Originating Department Community Development	By GPD	Approved for Agenda by:	Date: Time:	Number:
Agenda Section DEVELOPMENT BUSINESS		Item Variance and Revised Final Site Plan and Building Plans

Case 3335AB-00

1. A variance to reduce the required front setback from 35 feet to 17.8 feet for a building addition (Case 3335A-00)
2. Revised final site plans and building plans for additions to an existing industrial building (Case 3335B-00)

**Variance for front setback for building addition
And Revised FSP & BP for additions to existing building**

3335 B 00

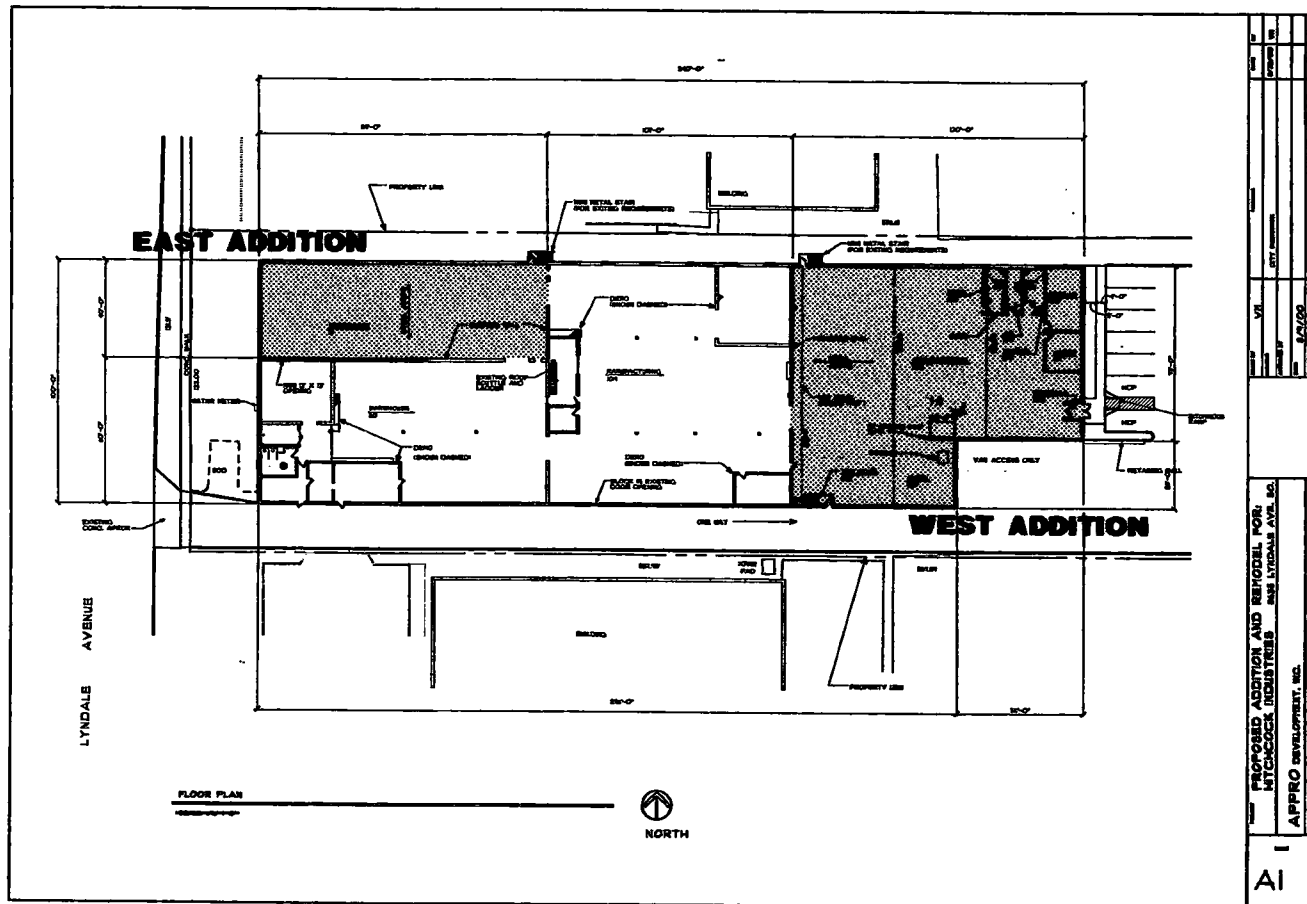
Section 19.42(c)(1) of the City Code requires that all setbacks shall be based on the planned widened right-of-way, which is 50 feet from centerline on Lyndale Avenue in this instance. The existing property line is 40 feet from centerline and the existing building has a setback of 27.8 feet from that property line. The west wall of the proposed northwest addition would match would be an extension of that existing west wall plane and have a 27.8 foot setback from the existing property line and a 17.8 foot setback from the planned widened right-of-way for Lyndale Avenue.

With the exception of the less than standard setback on the proposed west addition, the proposed additional site development does comply with all other applicable performance standards and many noncomplying aspects of the existing development will be brought into compliance, to include:

The applications were not reviewed by the Fire and Life Safety Committee. Public works comments include the following:

- Plat the property;
- Dedicate ROW to 50 feet along Lyndale Avenue and provide standard drainage, utility, and sidewalk easements along appropriate property lines;

- Clear one-way signage required along south driveway;
- No connection charges due;
- Provide proper radii on driveway entrance curbs, particularly on Lyndale;

- Street restoration compliance required;
- Use Bloomington Standard Details;
- Spec material 6" and 8" lines
- Complete SAC questionnaire;
- Put water meters where service enters building;

- Review cover, valving, utility line separation, and all existing property services with staff for detail needs;
- Place inspection manhole on west service;

- Review erosion control plan deficiencies with staff;
- Nine Mile Creek Watershed District permit required;
- Review storm calculations with staff for runoff control, storm cepter sizing, and other details; and

- Potential drainage problem on north side of building and can't drain roof to surface in that area.

In Case 3335B-00, staff recommends approval of revised final site plans and building plans for additions to an existing industrial building and site improvements at 8635 Lyndale Avenue subject to the following conditions being satisfied prior to the issuance of any grading or building permits:

- 1) Exterior building materials shall match those shown on plans approved in Case 3335B-00;
- 2) Building plans shall identify trash and recyclable material collection and storage area provided within the building as approved by the Fire Marshal and the Planning Manager;
- 3) Grading, drainage, utility and erosion control plans be approved by the City Engineer;
- 4) A SAC questionnaire be completed and submitted to the Department of Public Works;
- 5) Access, circulation and parking plans be approved by the City Traffic Engineer;
- 6) Erosion control measures be in place prior to issuance of grading permits;
- 7) Nine Mile Creek Watershed District permit be obtained
